TOWN OF MORRISTOWN DEVELOPMENT REVIEW BOARD
WARNED PUBLIC HEARING
COMMUNITY MEETING ROOM OF THE OLD TEGU THEATER
43 Portland Street in Morrisville, VT 05661
6:00 PM Wednesday, September 9, 2026

DEVELOPMENT REVIEW BOARD MEETING MINUTES OF AUGUST 12, 2026

TO: Morrisville DRB
FROM: Holden S. Thompson, EI, B. Dexter Lefavour, PE
SUBJECT: **N.A. Manosh 5 Mountain Minerals Application #2026-59 Response**
DATE: August 7, 2026
CC: Nick Manosh

C-2

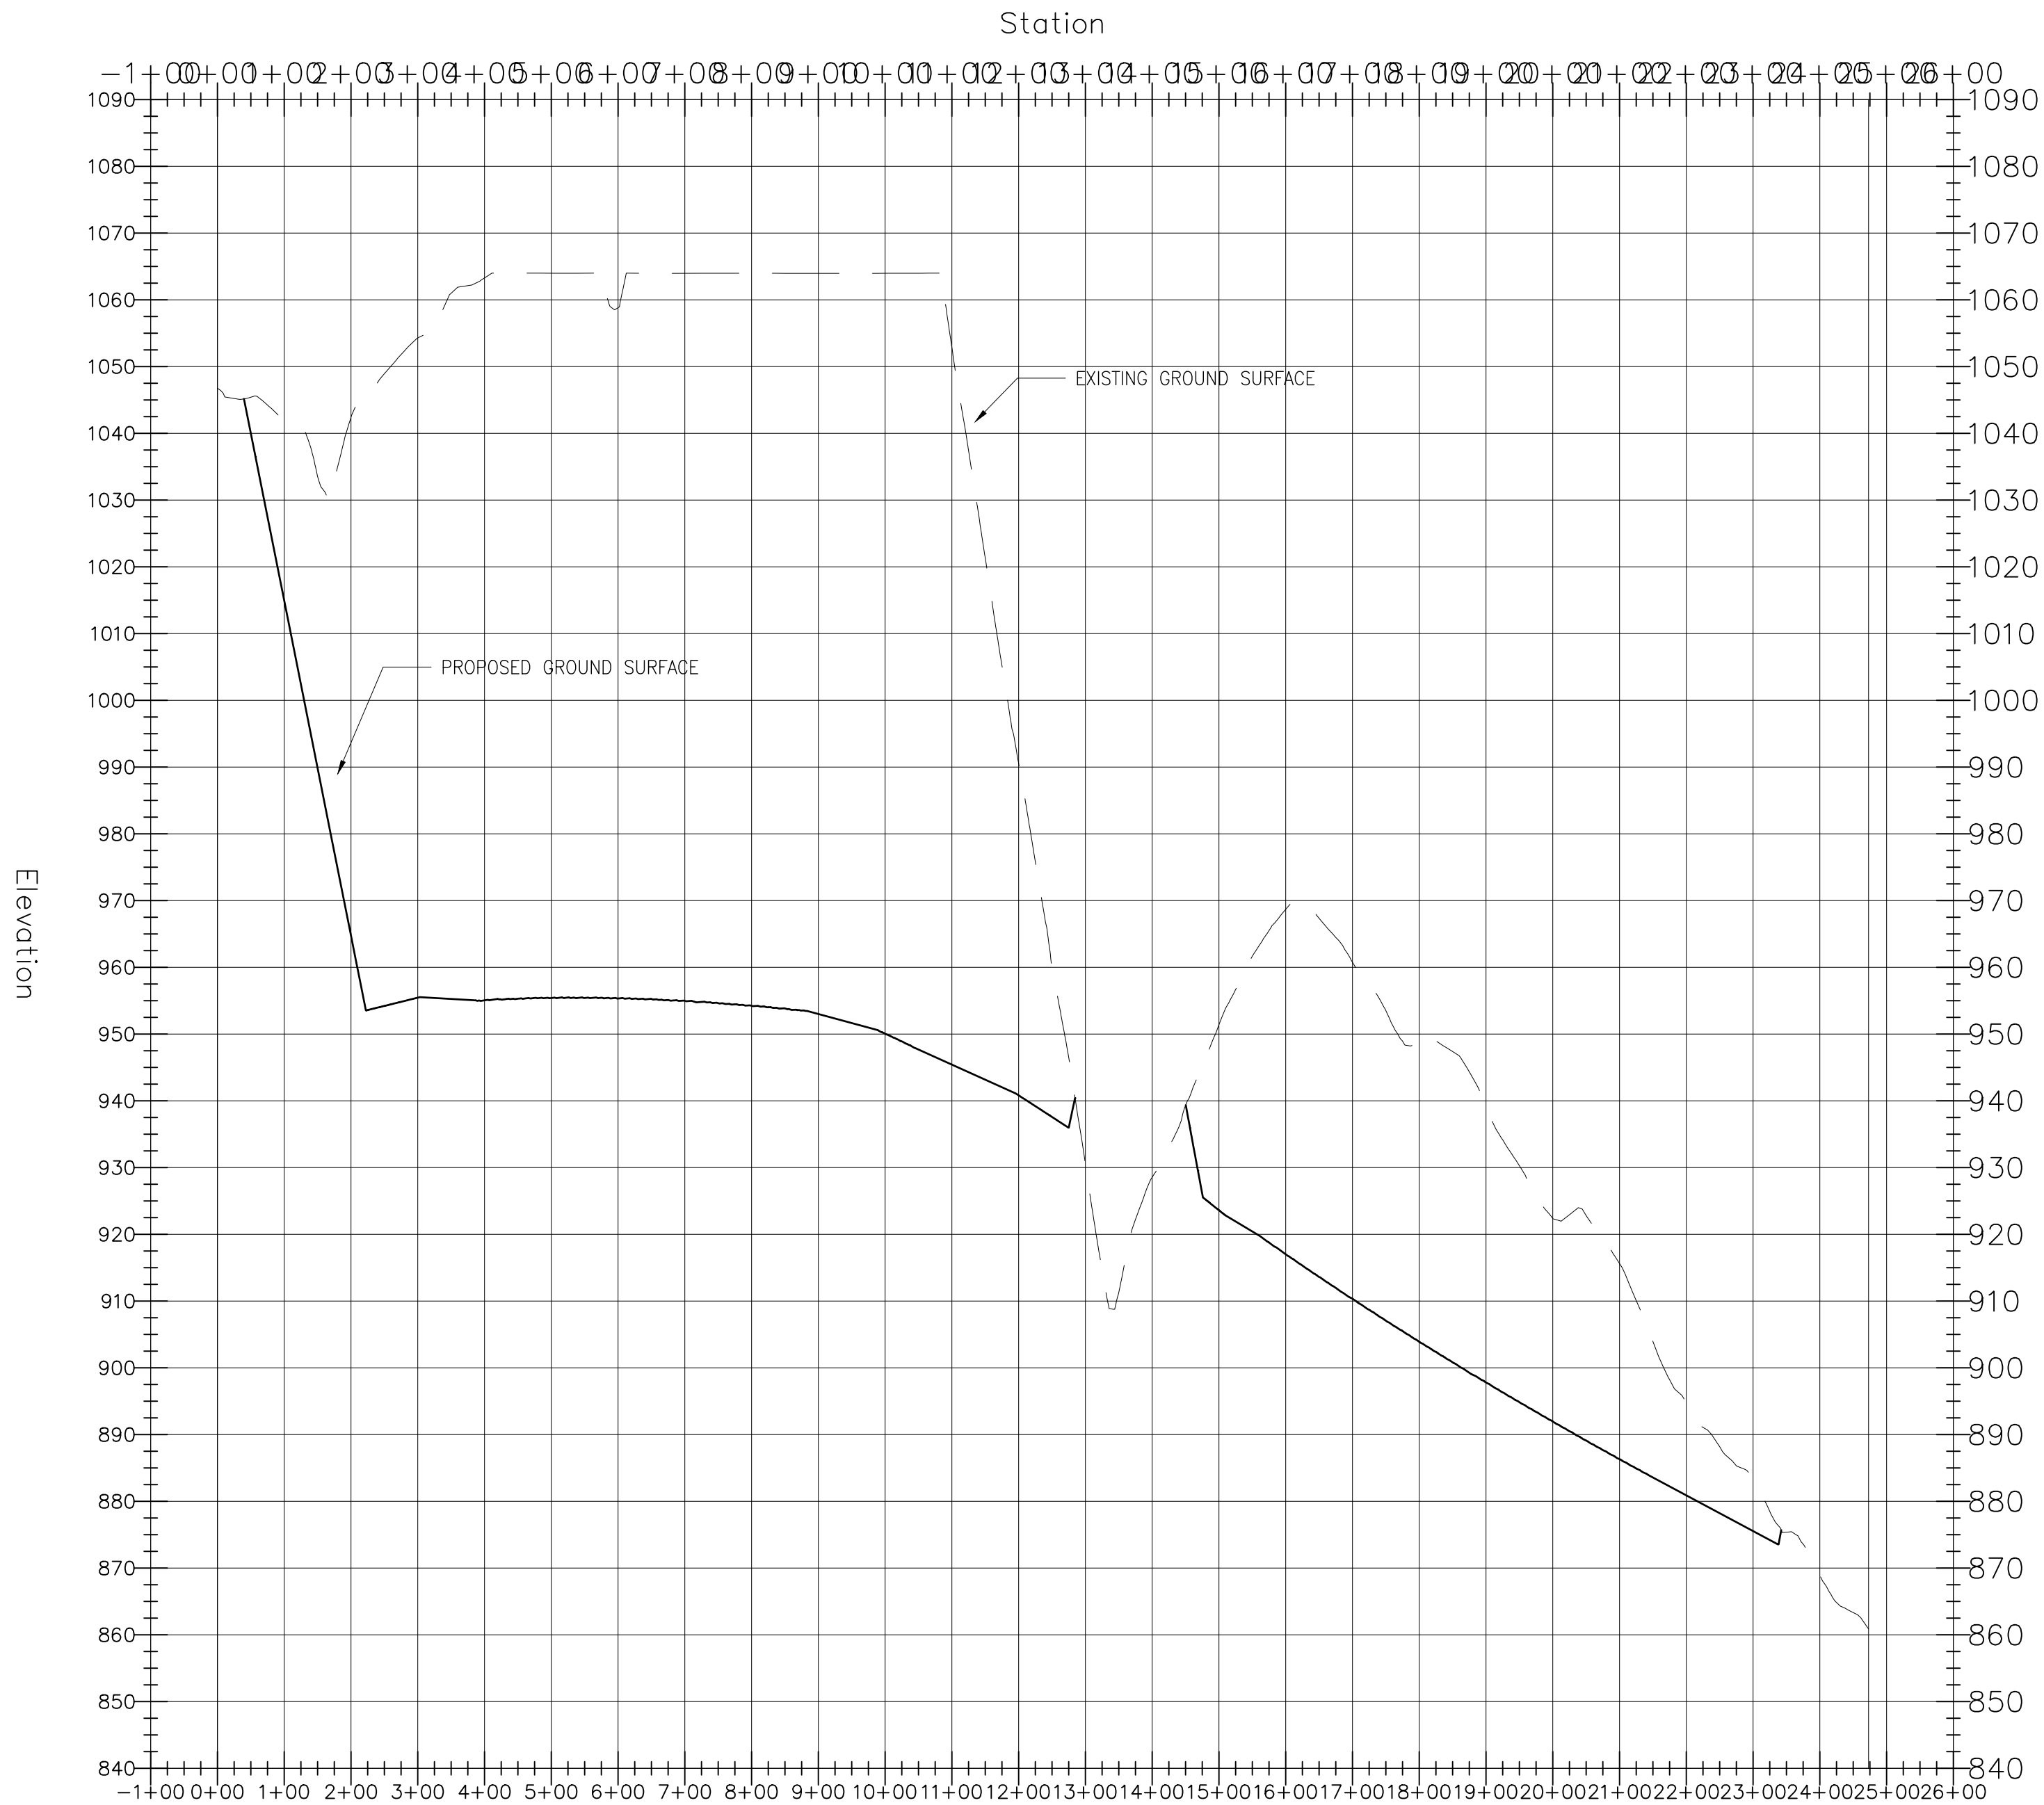
21. The Applicant's plan sets, Submittals C and F, appear to show extraction within 200 feet of the southern and northern property boundary of lot 09-027-1. In addition, Ferland Pit

Road appears to be within 200 feet (**Submittal F. does provide a scale on all plan sheets; however, the contours are not shown. Using the scale bar from Submittal F. with the contour lines of Submittal C. it appears to show that the extraction area is inside of the 200-foot setback noted in Section 485.5 of the 2023 bylaws. The Applicants should confirm this distance and make sure no extraction occurs within 200 feet of any lot line.**)

The staff notes indicate concern for setbacks to Ferland Pit Road and property lines to the South of proposed Lot 1. Ferland Pit Road will be used as an on-site access for the soil and water extraction with a common right-of-way serving the dwelling of Nick Manosh. There is also no longer a planned major subdivision which removes the property boundary that was of concern as seen on Sheet C-1. These changes were made to satisfy Section 485.5 of the 2023 Morristown Zoning and Subdivision bylaws.

The applicant will ensure any equipment or machinery on site observes this setback requirement. No sorting machinery or equipment will be operated within 300 feet of any property line as required by Section 485.6. A typical location plan for equipment location on the sites has been added to Sheet C-2.
